Council of the Isles of Scilly Delegated Planning Report Householder application

Application Number: P/21/054/HH

Proposal: Roof alteration for introduction of two dormers plus velux roof

Recommendation: REFUSE

Figure 1 As Existing

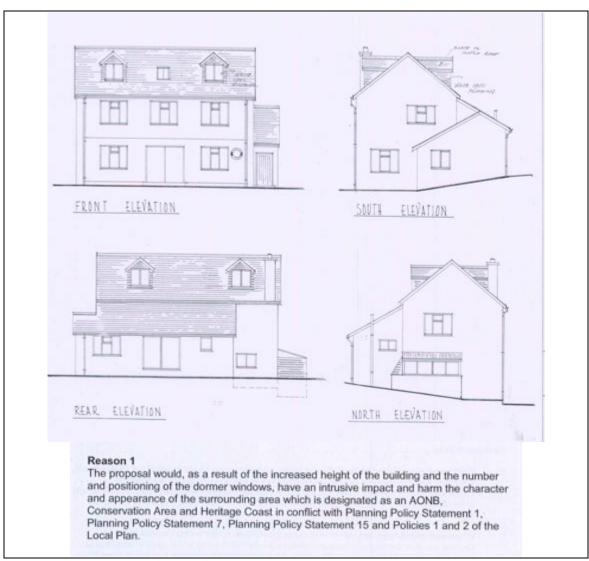
The proposed elevations, of which are shown in figure 3 above, are considered to be overly bulky in appearance. The house is a large two storey property situated in an elevated hillside position on Church Road. The blank dormer features are not considered to be particularly characteristic in terms of design. Some examples of nearby property have been considered:

Figure 7 1st, 2nd and 3rd Amendments

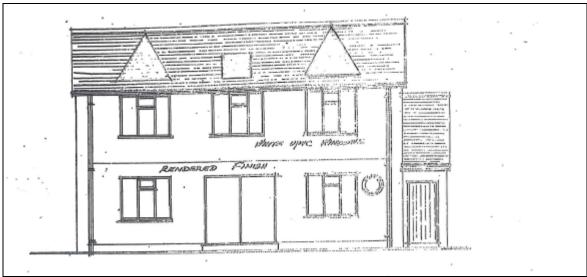
The first set of amended plans (1) were submitted after the applicant was asked to consider reducing the overall scale of the dormers to something less bulky. These plans were the subject of a conversation with the building inspector, particularly in terms of implications under the building regulations, as it was apparent that the head-height would be inadequate but if the applicant was successful at the planning stage and 'boarded out' the space or fixed a permanent means of access, it would be considered 'habitable' for the purposes of the building regulations. Clarification on the plans was therefore sort, in terms of adding dimensions to the drawings and requesting sections (existing and proposed). This resulted in the second set of amended plans (2). These indicated wildly inaccurate dimensions, which the applicant was asked to clarify. This resulted in the third and final set of amended plans, shown as (3) in figure 7 above (side elevation) and figure 8 (front elevation) being submitted as an amendment to the application. It is noted that with all three versions of the amended plans the size and position of the dormer were inconsistent (the side elevations all differed from the front elevation in terms of position and size). On the basis that the amended plans were inconsistent in terms of the side elevations and front elevations, and the dormers were stated to achieve

aesthetic improvements primarily, the applicant was again asked to scale down the dormers further and ensure the drawings were consistent. This resulted in a withdrawal of the amended plans and a reversion of the scheme back to the originally submitted dormers, as shown in figure 3 above.
